**Report to the Future Melbourne (Planning) Committee**

**Agenda item 6.2**

**Ministerial Referral: TPMR-2016-22  
42-44 Moray Street and 11-13 Hancock Street Southbank**

**21 March 2017**

**C. DESIGN PROPOSAL**  
GROUND FLOOR PLAN

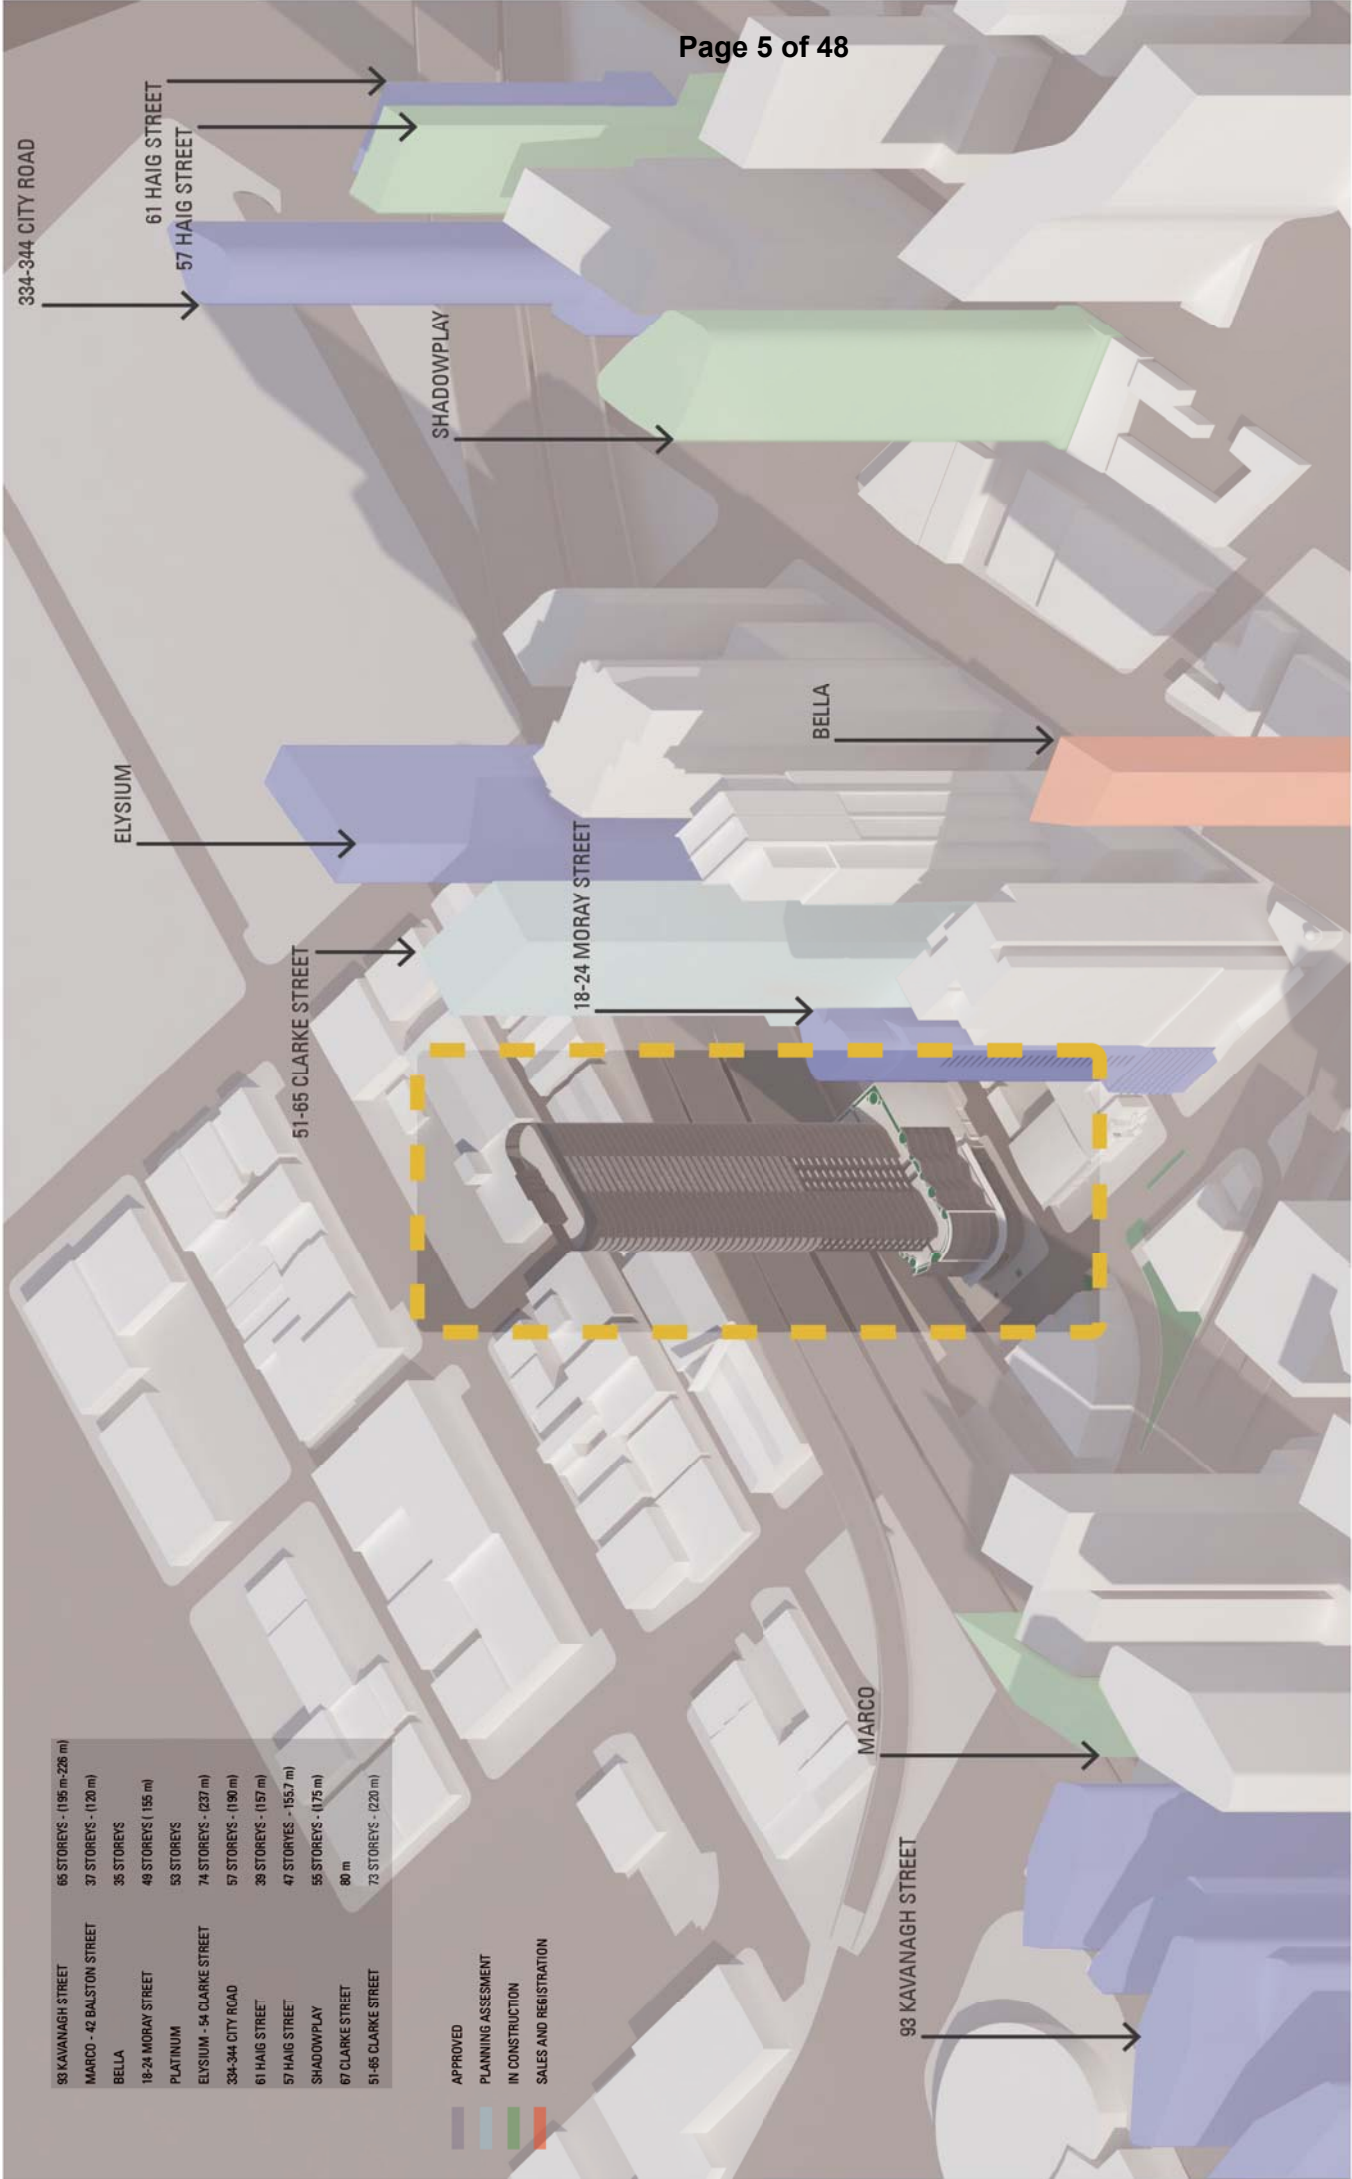
- We have some concerns regarding the treatment of the carpark entry and services on the side street and rear lane. We encourage the provision of 1:50 drawings for the building perimeter at the ground level to show material treatments and the design of any services, loading bay doors and vehicle entry points.

- The design of the canopy presently appears incongruous with the remainder of the treatment, and drawings appear to show two canopies in conflict with one another (at the first and second floor). We encourage a more integrated approach to weather protection as part of the redesign of the podium toward a heavier treatment.

- g) Details of the external material treatment of the carpark entry and services.
- h) Amendments to the internal layout in terms of window area for 'snorkel' bedrooms indicated on the indicative floorplan concept prepared by Peddle Thorp Architects dated February 2017 (TP-505A), storage and communal outdoor space in accordance with the Victorian Government's *Better Apartments Design Standards* December 2016.

**C. DESIGN PROPOSAL**  
TYPICAL TOP OF PODIUM (LEVEL 6)

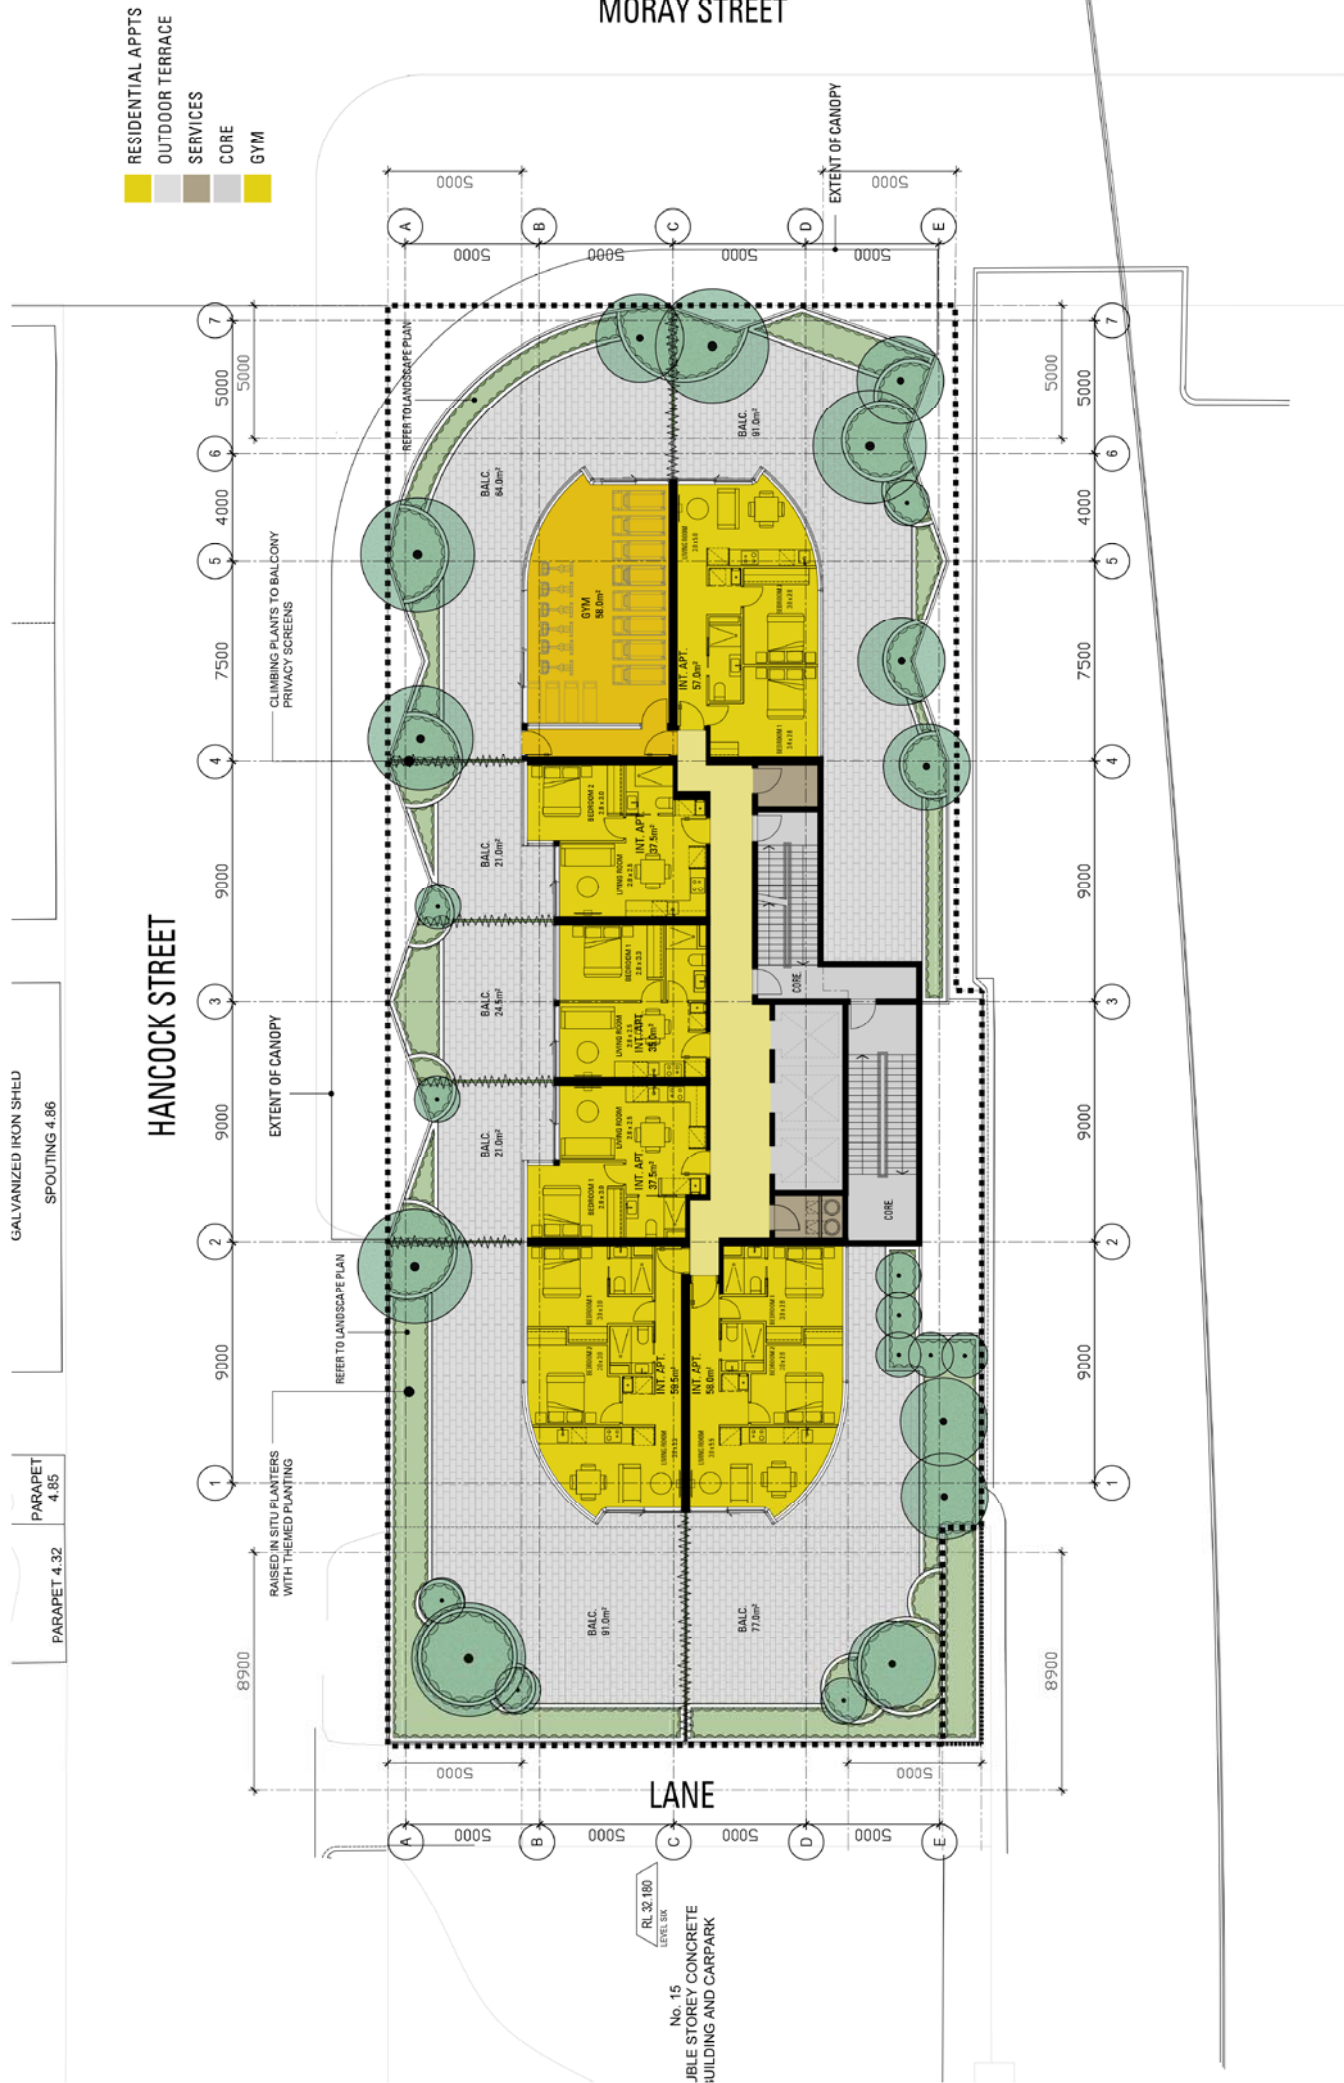
- a) All two bedroom apartments within the extreme east and west of the proposed upper form at Levels 6 to 44 (TP-206 to TP-236 and TP-502 and TP-503) to be amended to be generally in accordance with the indicative floorplan concept prepared by Peddle Thorp Architects dated February 2017 (TP-503A). All elevation plans must also be updated to reflect the amended changes

**C. DESIGN PROPOSAL**  
TYPICAL UPPER TOWER FLOORPLAN (LEVELS 45-50)

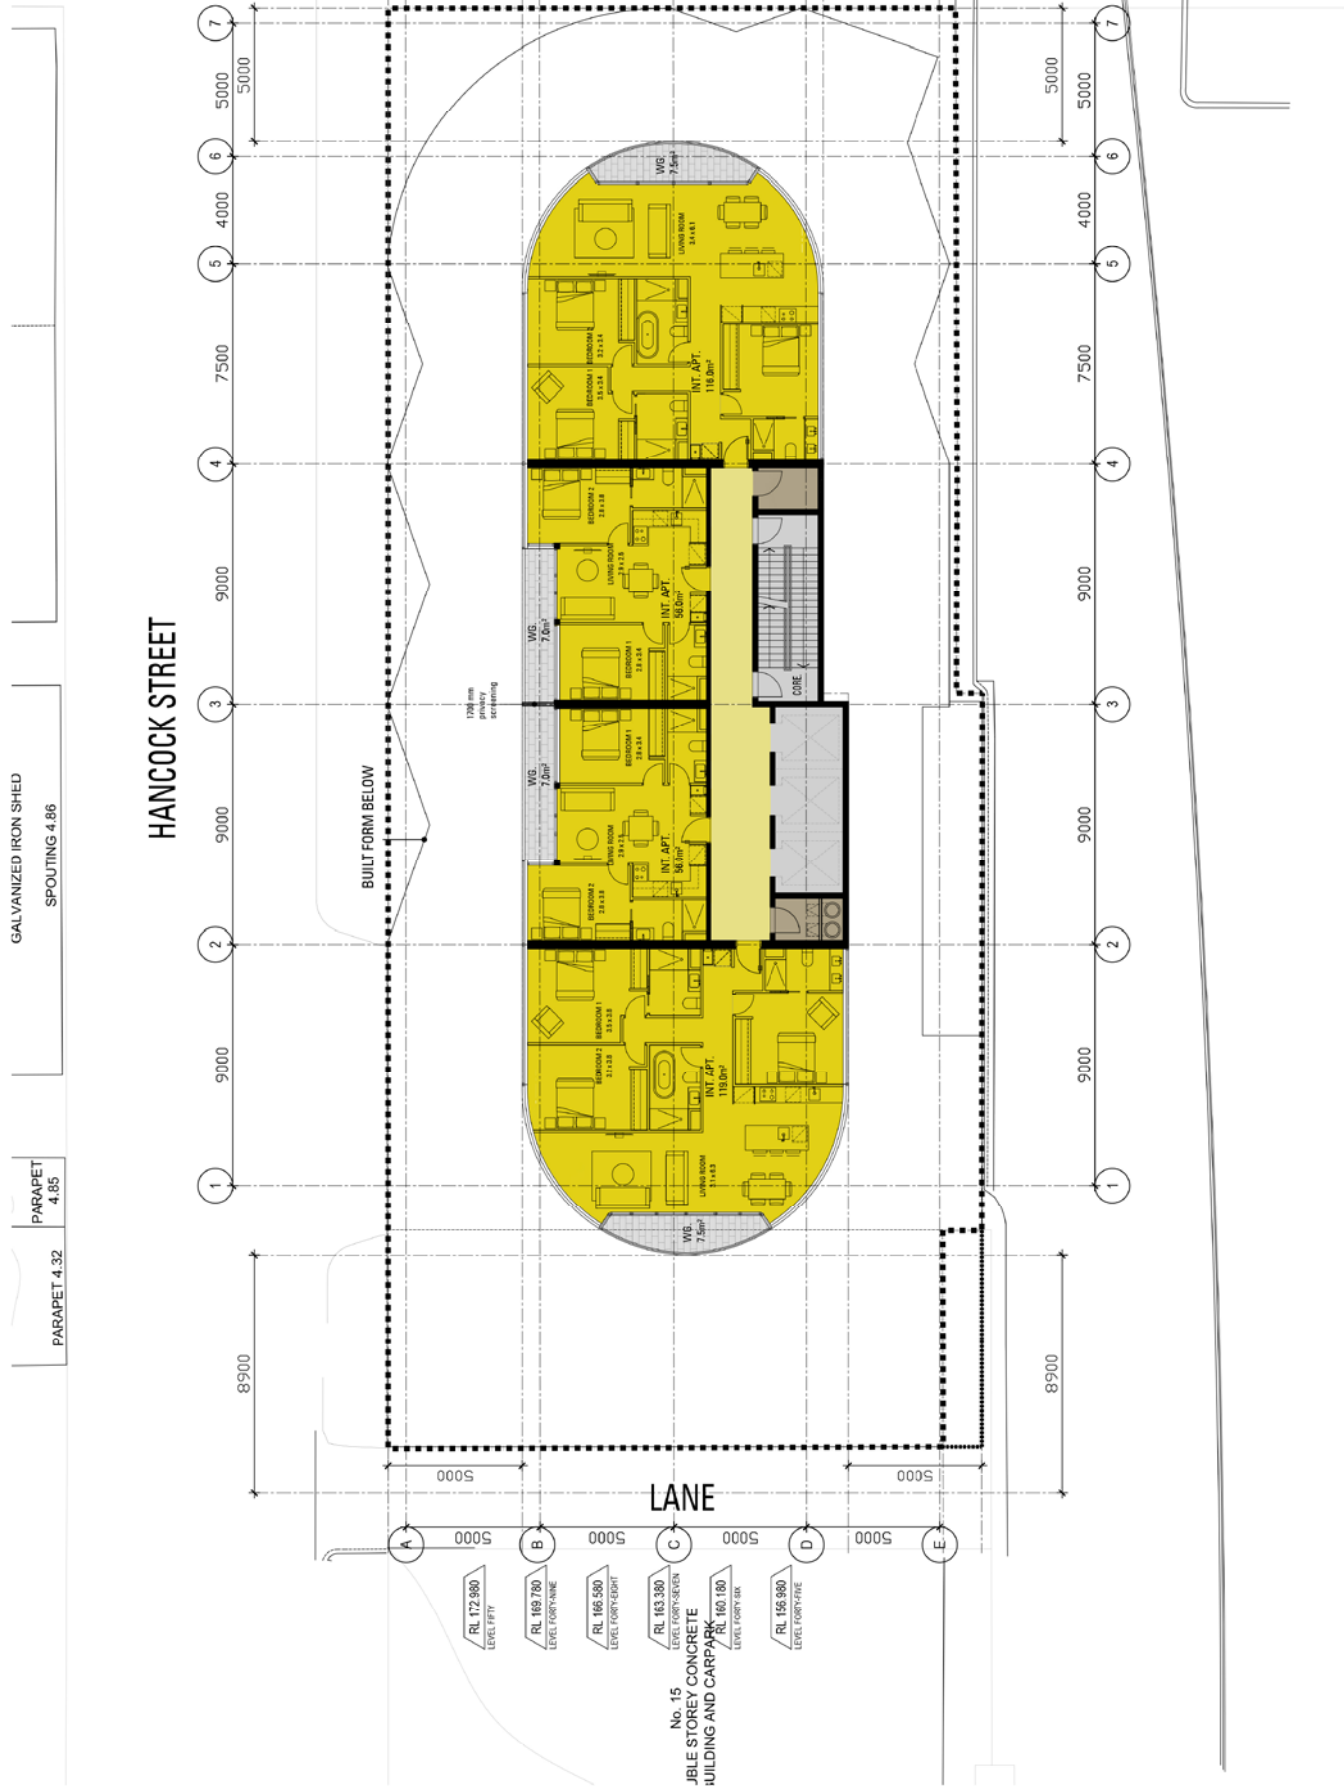
- b) All north-facing two bedroom apartments between Levels 36 – 50 (TP-236 to TP-245 and TP-504 and TP-505) to be amended generally in accordance with the indicative floorplan concept prepared by Peddle Thorp Architects dated February 2017 (TP-505A). All elevation plans must also be updated to reflect the amended changes
